RE: PROPOSED DEVELOPMENT OF 60MWP PHOTOVOLTAIC (PV) PLANT LOCATED ON OPPOSITE SIDES OF R555 AND TO THE SOUTH OF THE STEELPOORT RIVER ON VARIOUS FARMS WITHIN FETAKGOMO-TUBATSE LOCAL MUNICIPALITY OF SEKHUKHUNE DISTRICT

**ENVIRONMENTAL IMPACT ASSESSMENT AND WATER USE AUTHORISATION PROCESS FOR THE 60MWp PHOTOVOLTAIC PLANT ASSOCIATED WITH THE TUBATSE FERROCHROME SMELTER, STEELPOORT, FETAKGOMO TUBATSE LOCAL MUNICIPALITY**

**COMMENTS ON THE DRAFT SCOPING REPORT FOR THE DEVELOPMENT OF A 60MWP PHOTOVOLTAIC(PV) PLANT ASSOCIATED WITH THE TUBATSE FERROCHROME(TFC) SMELTER, FETAKGOMO TUBATSE LOCAL MUNICIPALITY, LIMPOPO PROVINCE.**

**Environmental Authorisation for the 60MWp Photovoltaic Plant associated with the Tubatse Ferrochrome Smelter, Steelpoort, Fetakgomo Tubatse Local Municipality**

Figure 1: Conservation categories and importance according to the Limpopo C-Plan (2013)

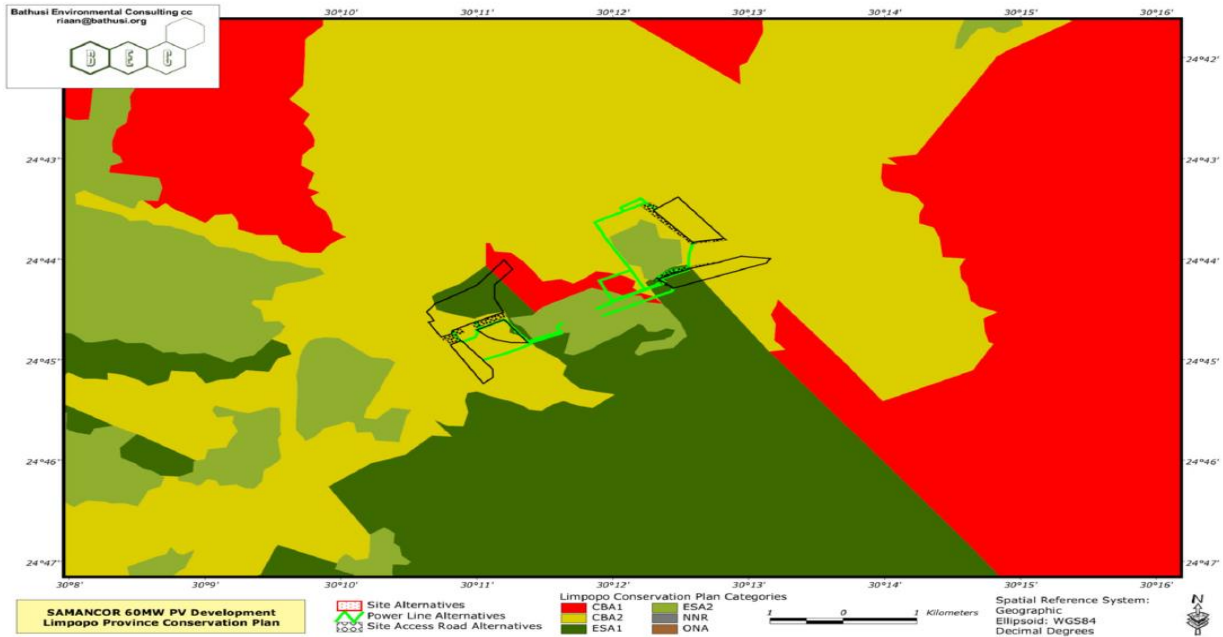
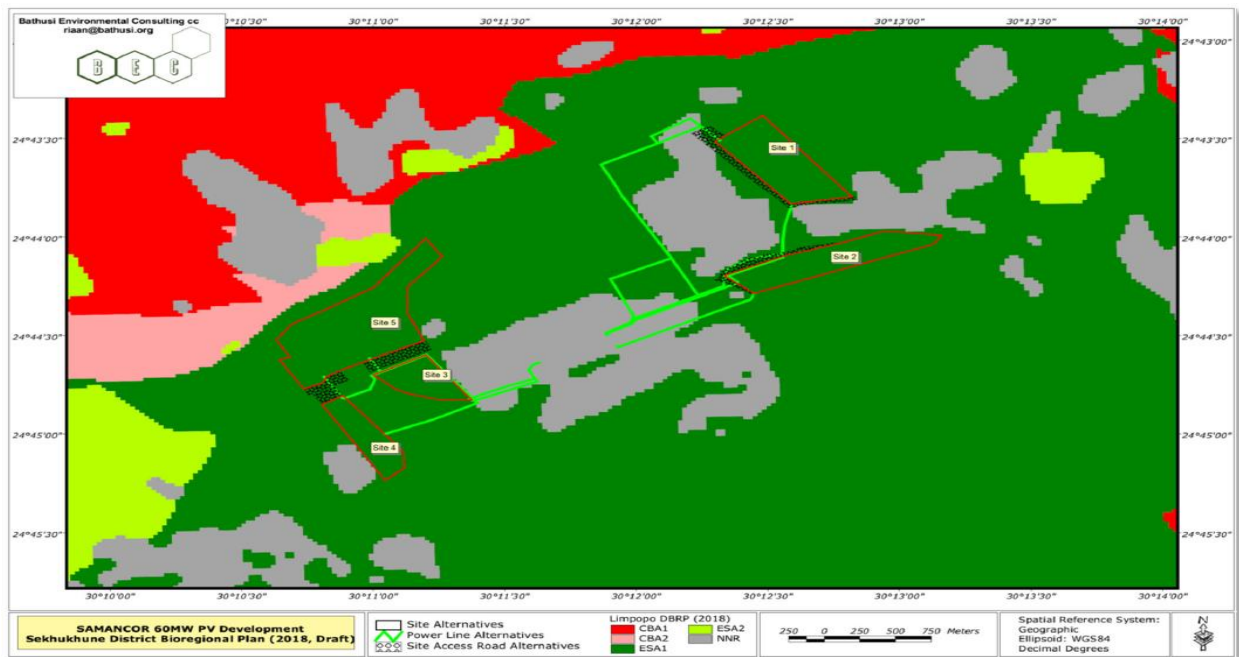
This serves as an acknowledgement for comments received on 14 July 2021, which stated:  
*“The proposed development site falls within the Critical Biodiversity Area (CBA) 2 in terms of the Conservation Plan of 2013. Therefore, it must be noted that industrial infrastructure activity is an incompatible activity within CBA 2.”*

The Environmental Scoping Report and subsequent Biodiversity Assessment has considered the relevant legislation, the Limpopo Conservation Plan (C-Plan) 2013 and the Sekhukhune District Municipality Bioregional Plan (BRP) 2020 which was gazetted on the 27 March 2020 as per the Provincial Government Notice No. 3074. As indicated in the Environmental Scoping Report (page 73), *“An appraisal of the BRP categories, specifically in comparison with the Limpopo C-Plan, provides for a more accurate and appropriate categorisation of remaining areas of natural habitat within the development footprints. Where the Limpopo C-Plan (Figure 1) indicates elevated conservation contribution and status, the BRP more accurately describes land transformation and habitat deterioration that is associated with the fragmented and isolated portions of woodland habitat in the immediate surrounds of Steelpoort. The discrepancy between the 2 datasets is likely a result of refined and more recent interpretation of background layers. According to the BRP (Figure 2), all sites are within the Ecological Support Areas (ESA) 1 category.”*

Upon consultation with the Department of Forestry, Fisheries and the Environment, it was advised that the Sekhukhune District Municipality BRP 2020 is the most relevant and information presented in the BRP supersedes what is presented in the Limpopo C-Plan (2013).

In light of the above, and in the view of the comments received from the Limpopo Department of Economic Development, Environment and Tourism, RHDHV would like to enquire whether the Limpopo C-Plan (2013) would still take precedent over the Sekhukhune BRP (2021), noting that the BRP has been subject to further refinement which can be considered more reflective of the present conditions within the Sekhukhune District Municipality. The Department's comment on this would be much appreciated.

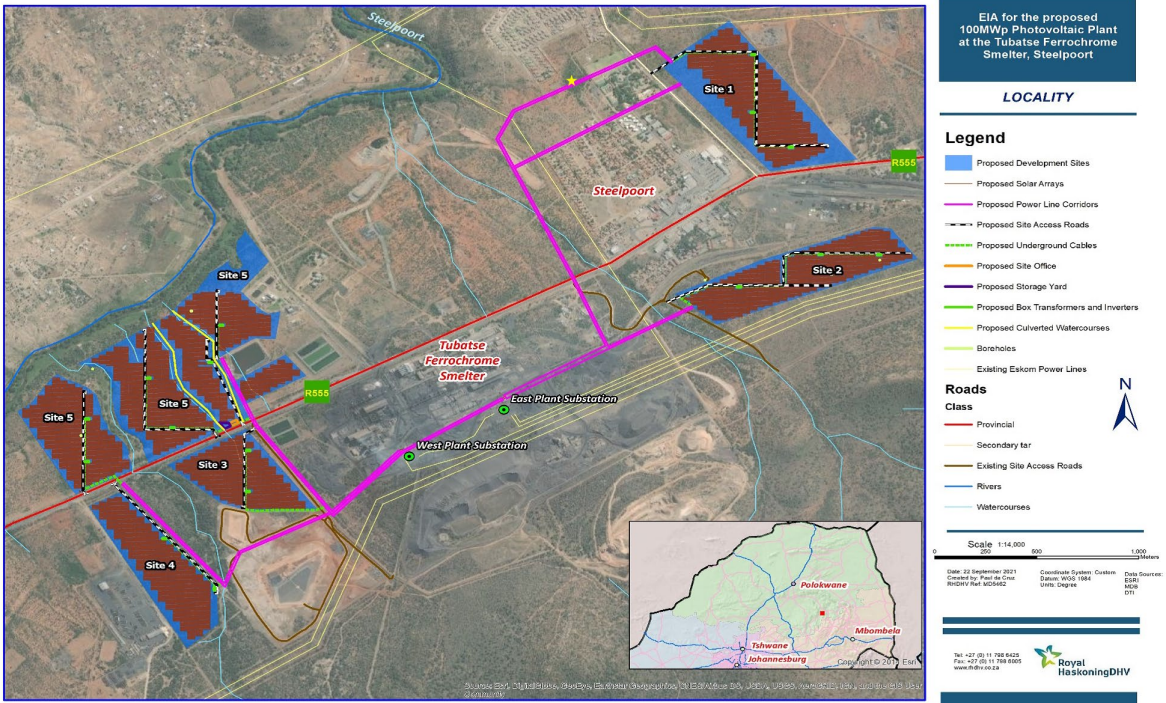
As per our telephonic conversation, I understand that there are services that run under that area due to the housing development that could be disrupted by the powerline alignment as provided to you. I just would like to reiterate that the consent from is purely to make landowners aware of any infrastructure that may impact your property and allow you to provide further recommendations which will be put forward to the department of Forestry, Fisheries and the Environment (DFFE), who will then take all this information into account in issuing their decision.

My recommendation, if you are in agreement, that you sign the form but include your concerns and the recommendation that the powerline be moved to the bottom end of Site 1 and then we can put this forward to the engineers to provide a comment on? Just to note all comments is also collated into a comments and response table that will be provided to the department as well. The consent form as provided by you will also be sent to the department.

Please could you have a relook in this regard

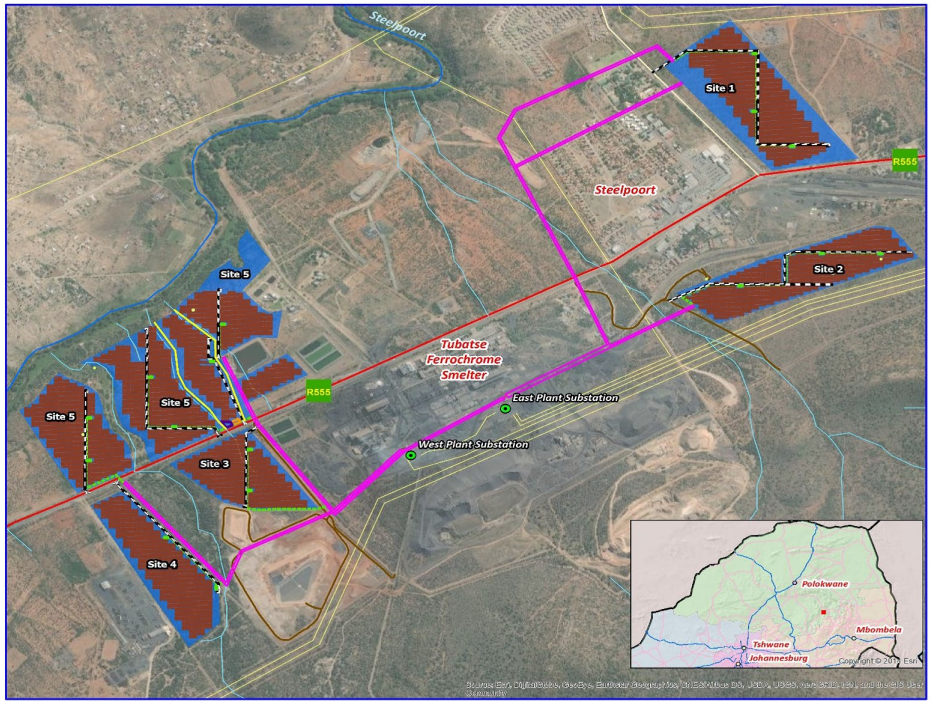
Can you indicate that purple portion on the below?
